DRAWING		118 ON MONJOY HILL - TENANT A DUCTWORK		DRAWING: SKMI.1	
<input type="checkbox"/> FIELD ORDER	<input type="checkbox"/> CHANGE ORDER	<input type="checkbox"/> SKETCH			
DRAWN BY K.F.M.	CHECKED BY K.F.M.	DATE 02.12.2015			
SCALE NOTED	SHEET: 1	OF: 1			
		 MECHANICAL SYSTEMS ENGINEERS ROYAL RIVER CENTER, UNIT #10 10 FOREST FALLS DRIVE YARMOUTH, MAINE 04096 FACEBOOK: MECHANICAL SYSTEMS ENGINEERS 207-846-1441 © COPYRIGHT 2015

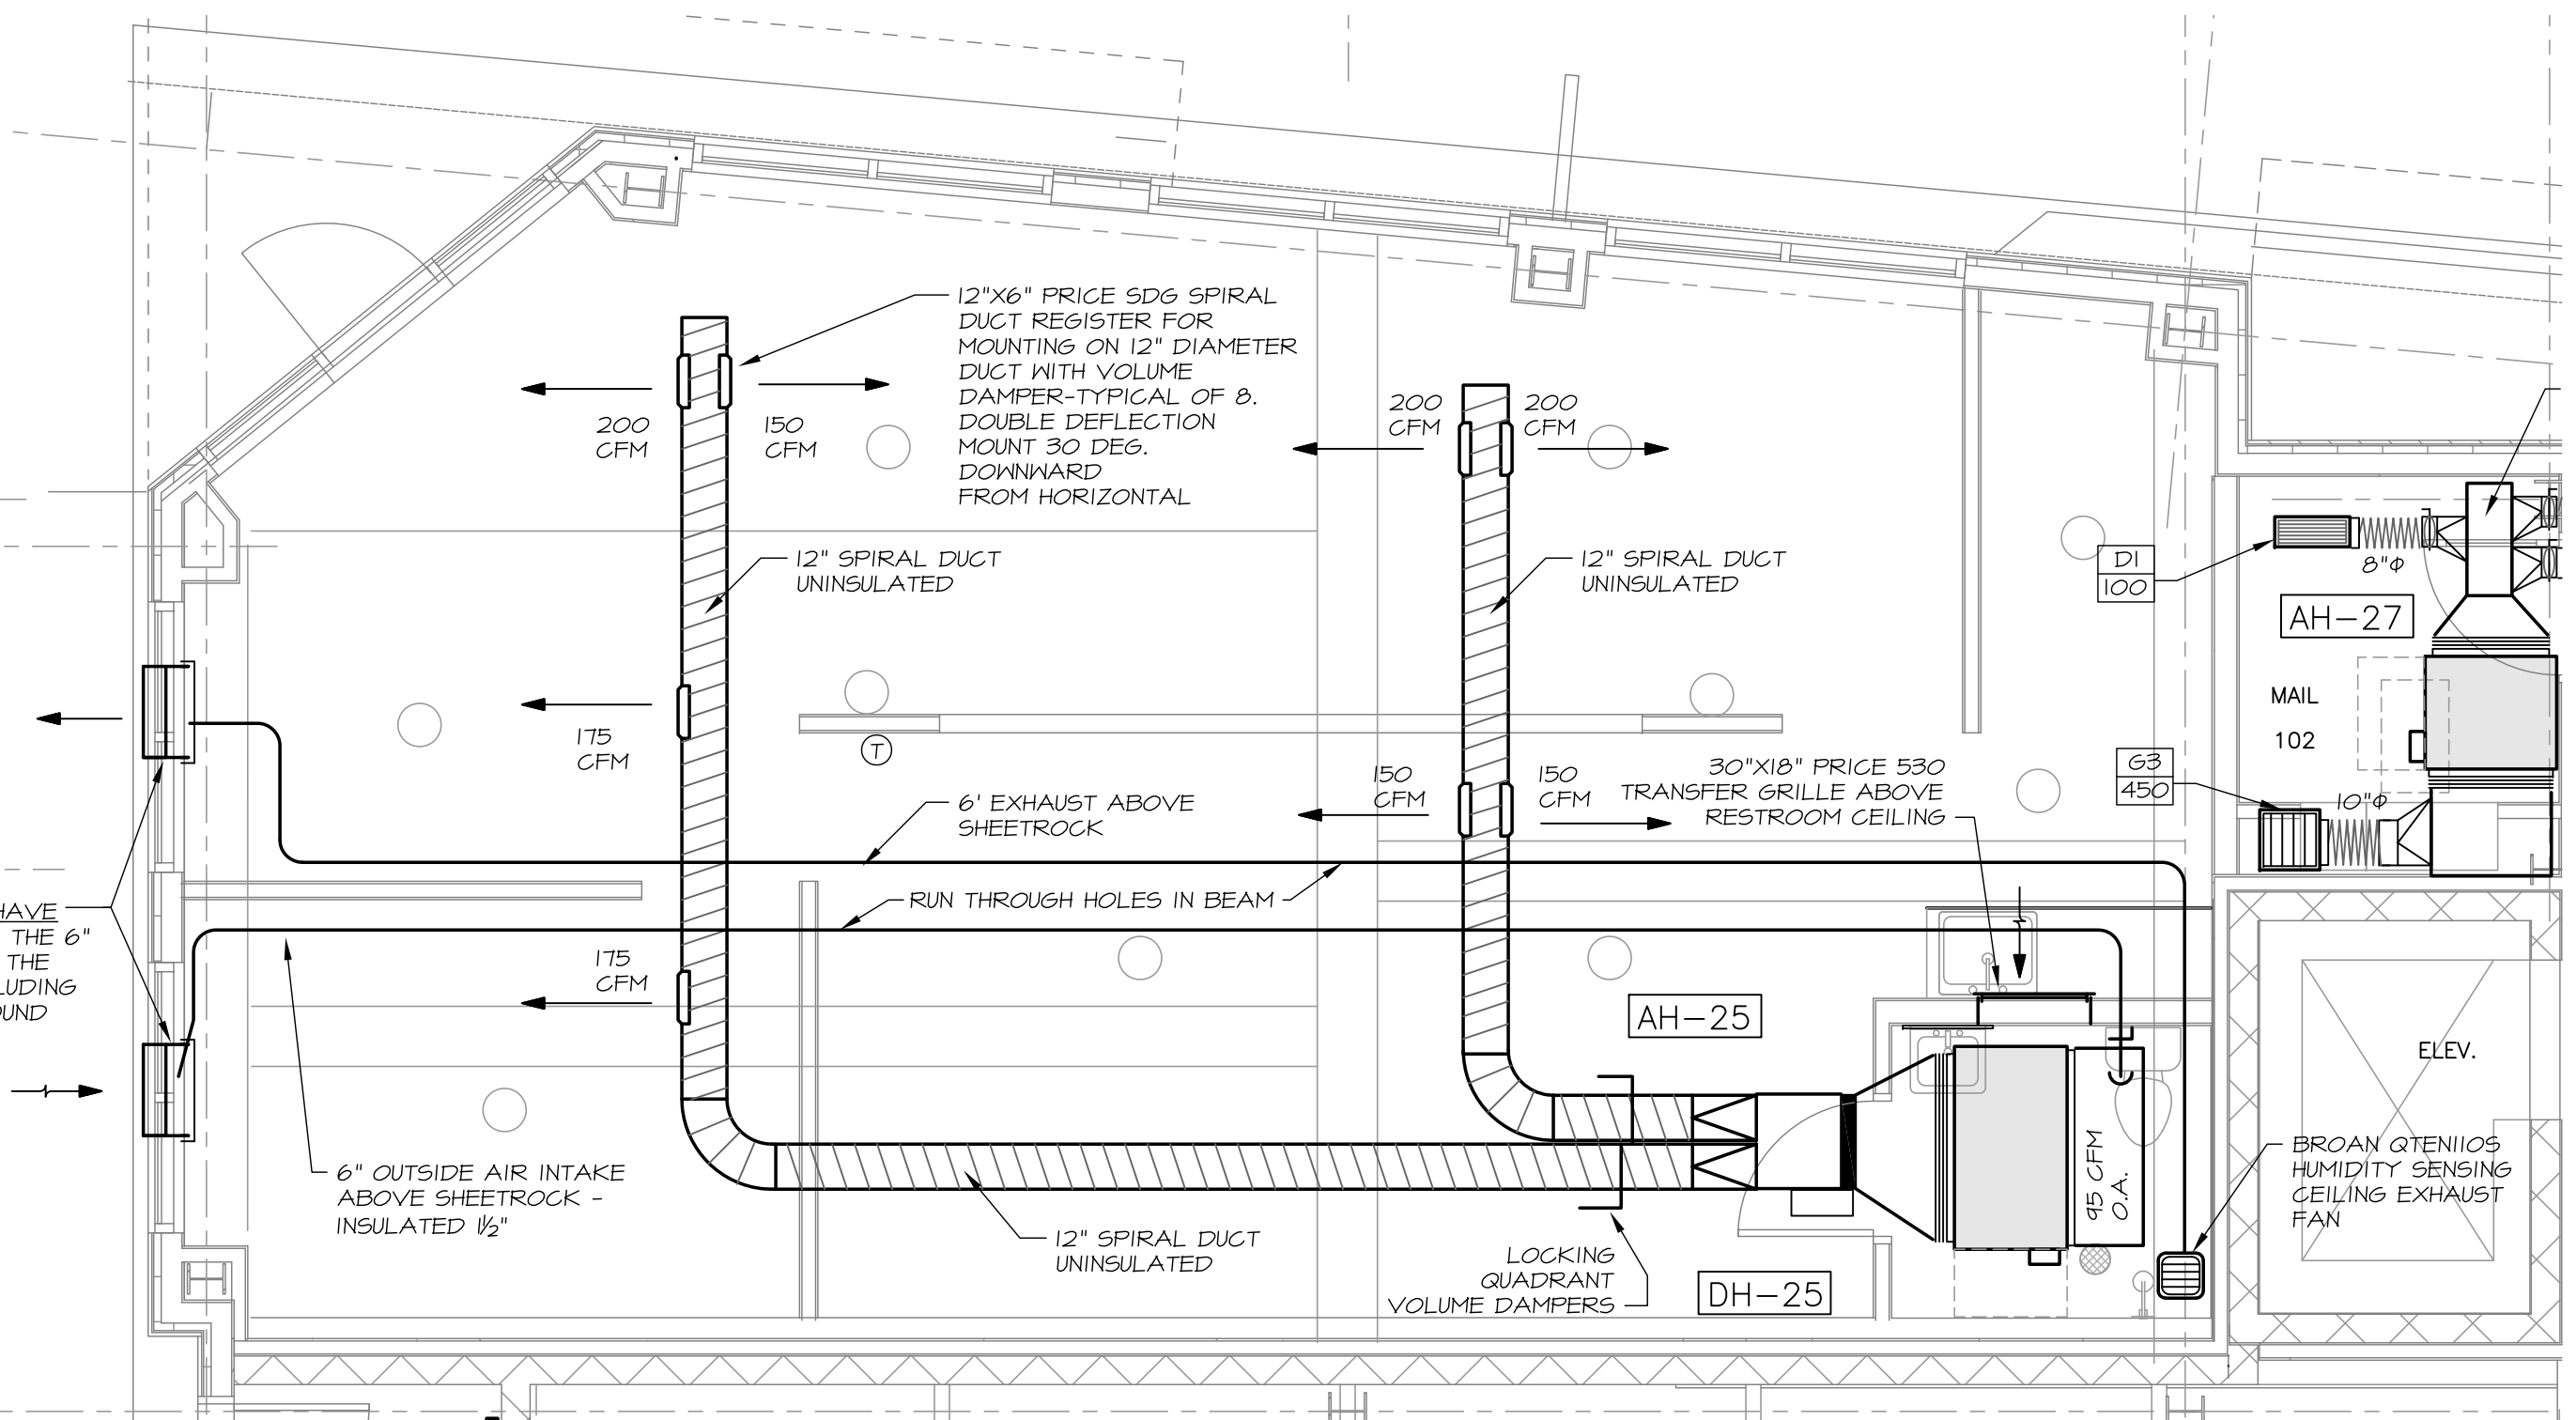
NOTE - DO WHAT YOU HAVE TO IN ORDER TO MAKE THE 6" ROUND DUCTS TIE INTO THE EXISTING LOUVER- INCLUDING
 - TRANSITION TO 5" ROUND
 - 2"X10" DUCT
 - 6" OVAL DUCT
